Nomination Form
Anadromous Waters Catalog

Name of Water Body Fish Creek

Nomination # 24-528

CORRECTION

Figure 1.—111-50-10690 route correction map.

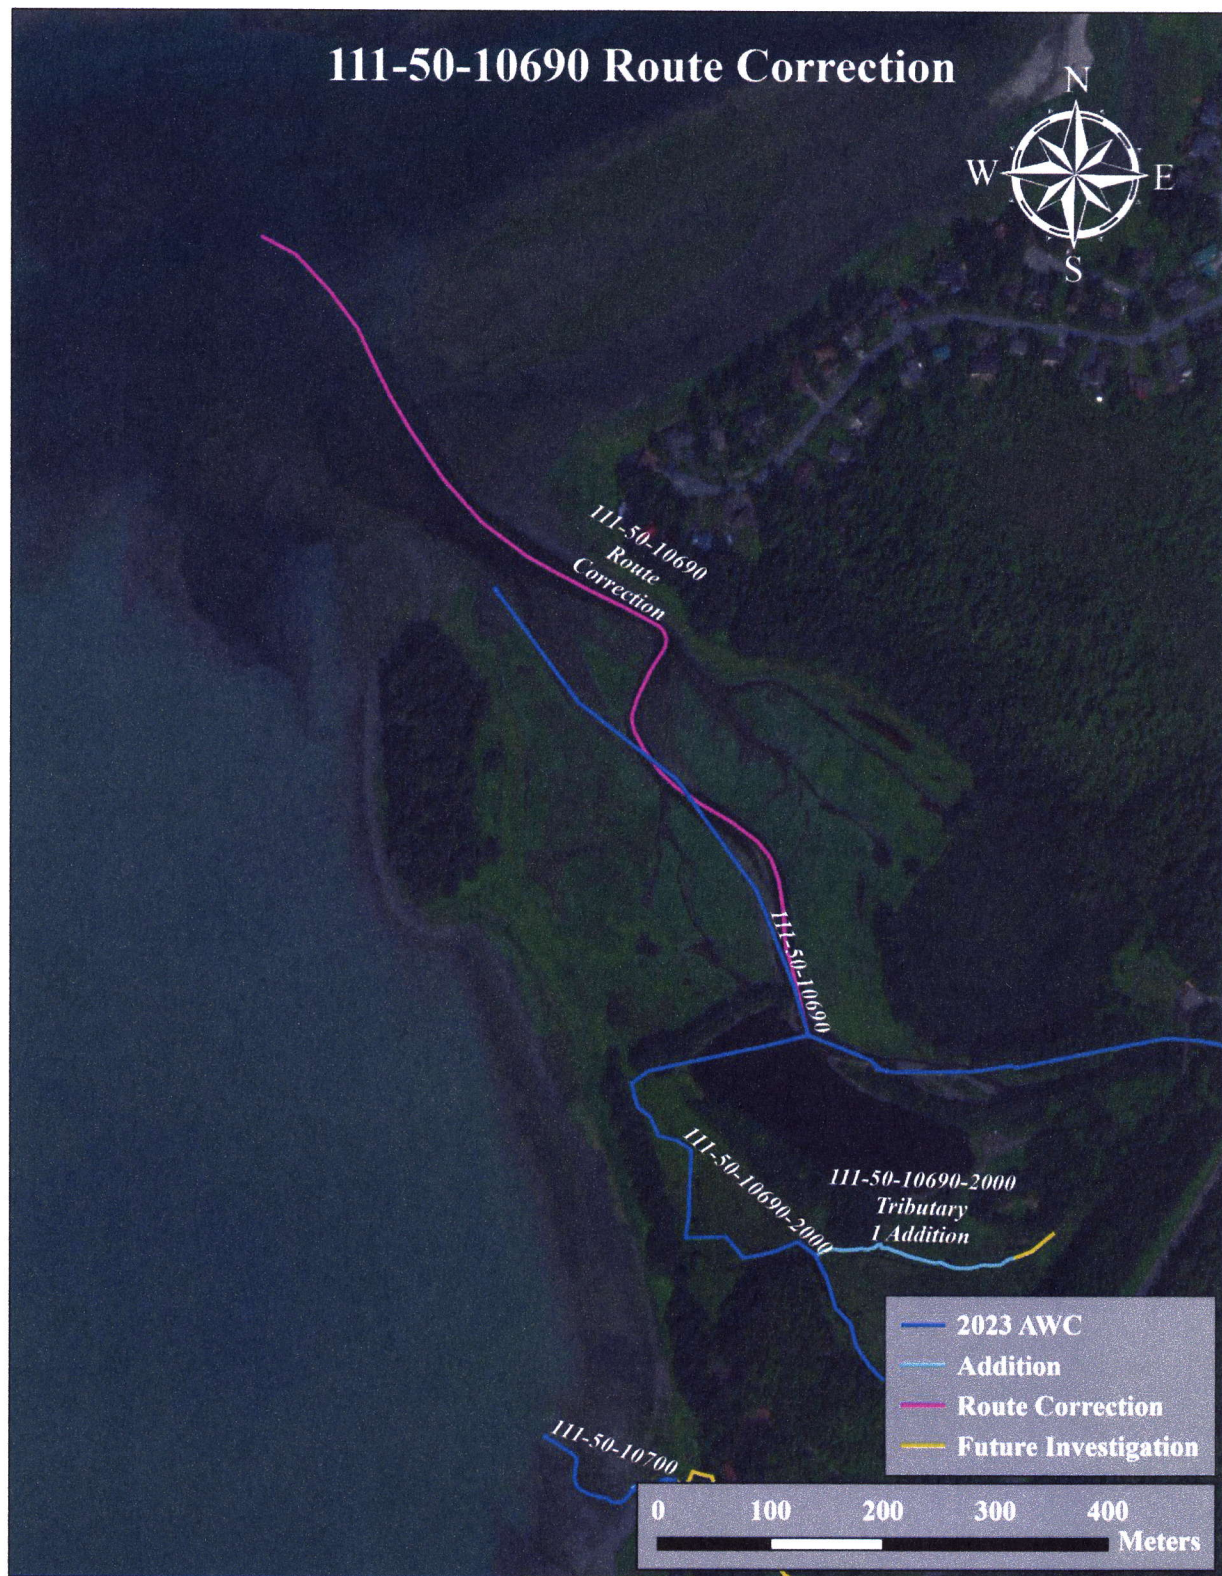
Findings: We surveyed this cataloged stream and found that the stream path is incorrectly mapped. The lower reach of the stream should be extended for clarification, particularly in light of potential alternatives identified for eventual construction of a second bridge crossing between Juneau and Douglas.

Recommendations: Correct Stream No. 111-50-10690 in the anadromous waters catalog to reflect the field verified stream path. Please extend stream into the intertidal (Figure 1).

-UPDATE/RELOCATE mouth point location of existing AWC Stream #111-50-10690 "Fish Creek" to better approximate the location of Mean-Low-Water (MLLW).
